CITY OF ATLANTA

EAST AREA WATER QUALITY CONTROL FACILITY IMPROVEMENTS

FC-4906A AND FC-7383A

Question from Brandon Dow Lakeshore Engineering *on Tuesday, Aug 30, 2022 at 01:08 PM EDT*

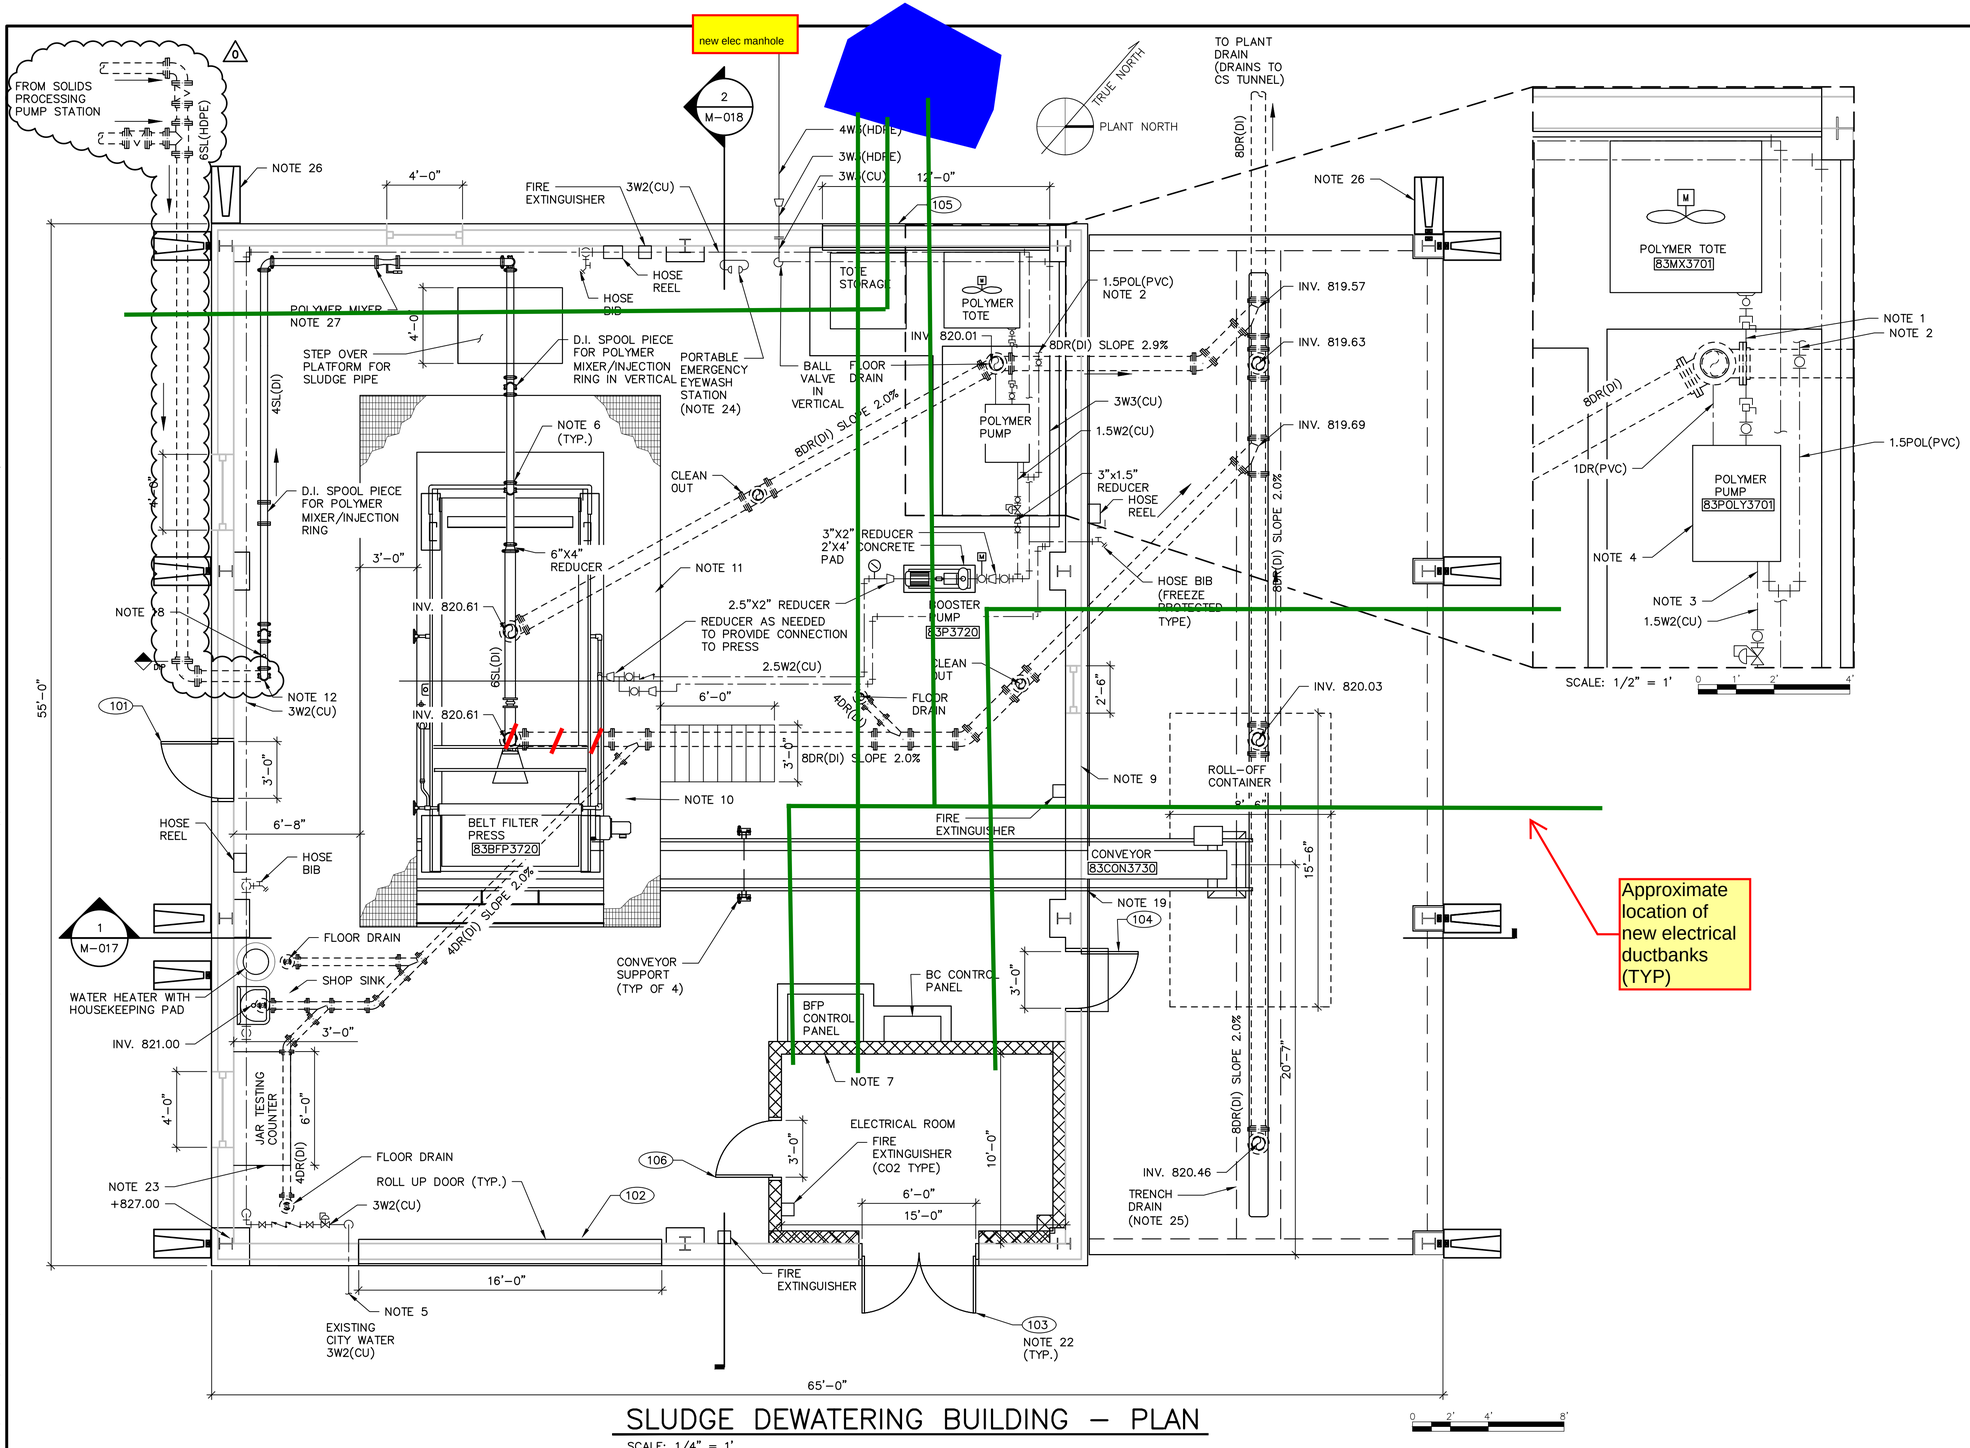
For the pipe encasement under the solids dewatering building we request that the top of the encasement be 8" above the horizontal pipe. This will aid in the installation of the additional electric ductbank. See the sketch for details. Please advise.

RFI-54

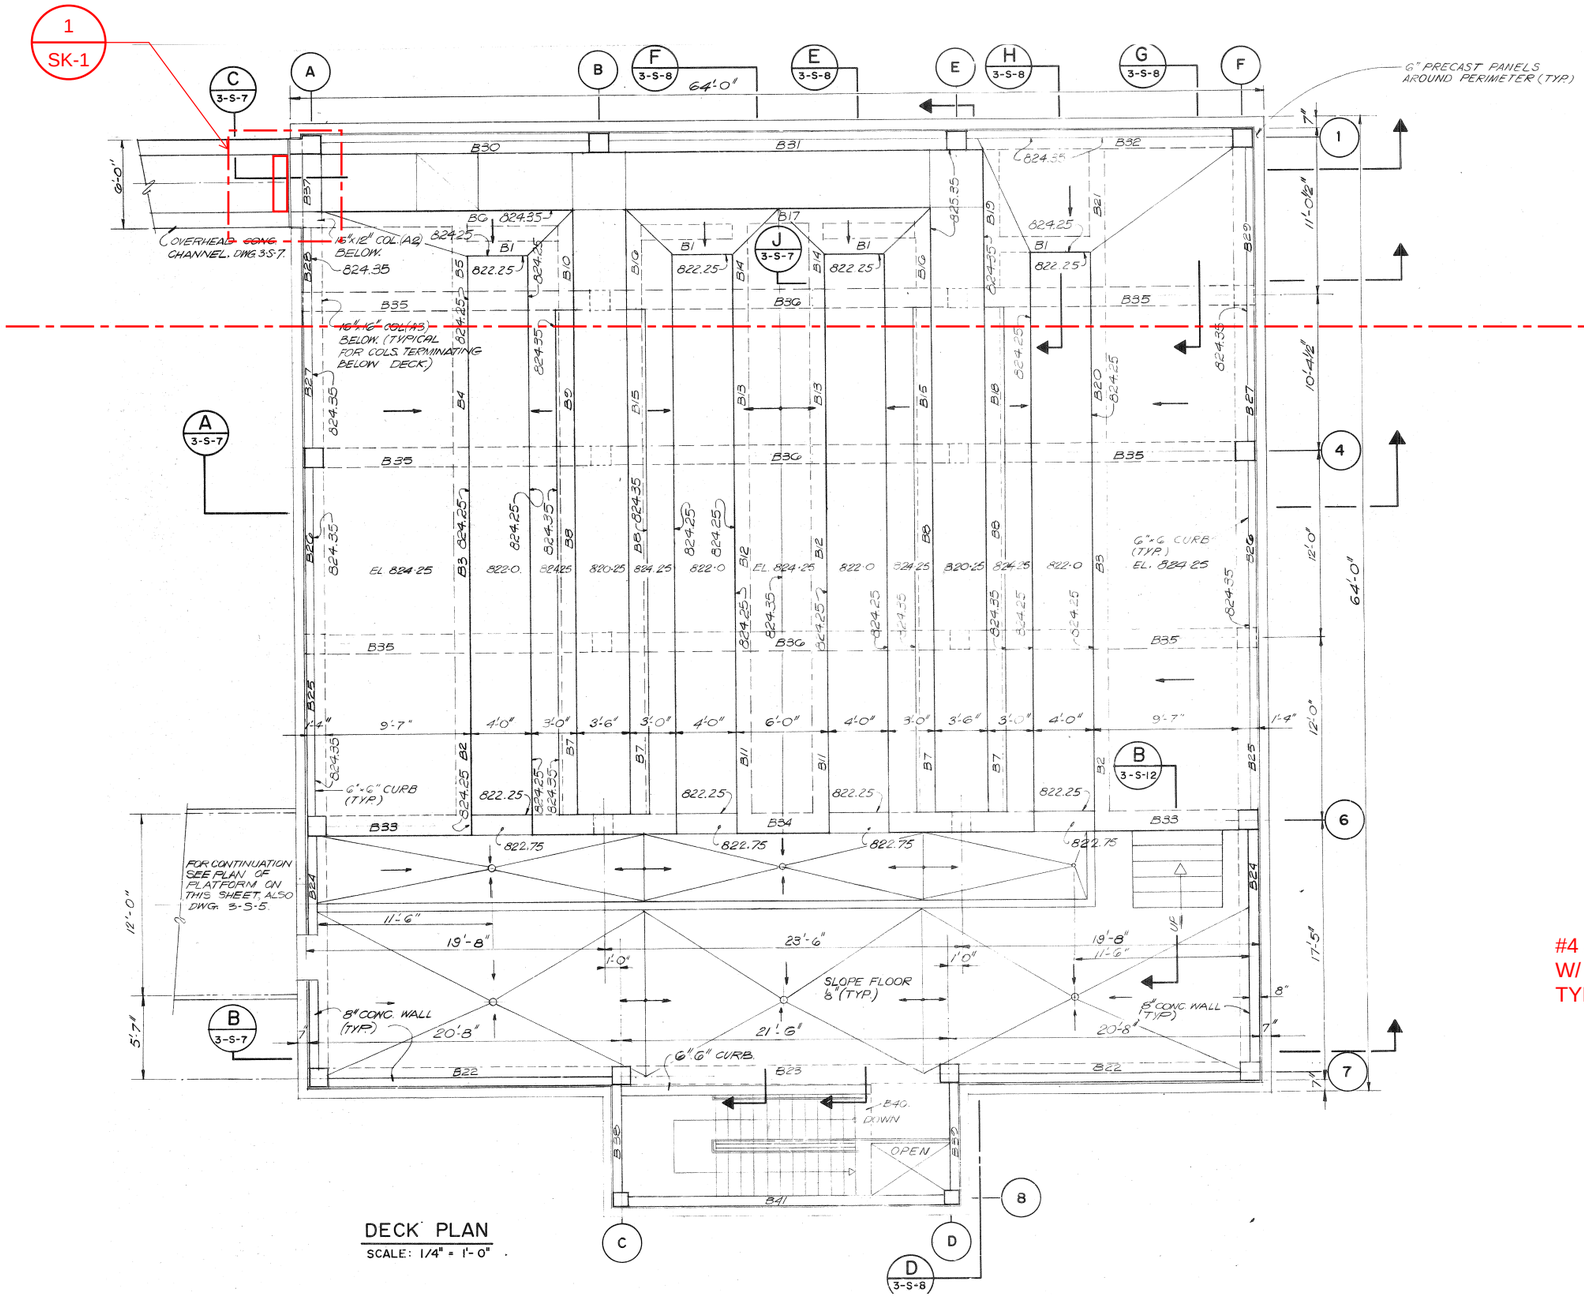
Specification Section 03930, Section 09900, Submittal 09900-97.0, and RFI 47 response for concrete repair and coating application information.

ARCADIS RESPONSE: Following the site visit by Arcadis' structural engineers last week, it was confirmed that the water entering into the chemical building is due to a pipe break in the sedimentation basin troughs outside of the building, leaking water into the elevated trough that connects to the chemical building. The water was entering the abandoned building causing a flood. In addition, the building floor drains appeared to be clogged, thus not helping with water drainage. No structural issues were found in the chemical building that would lead to a water leak. The following repair recommendations are proposed:
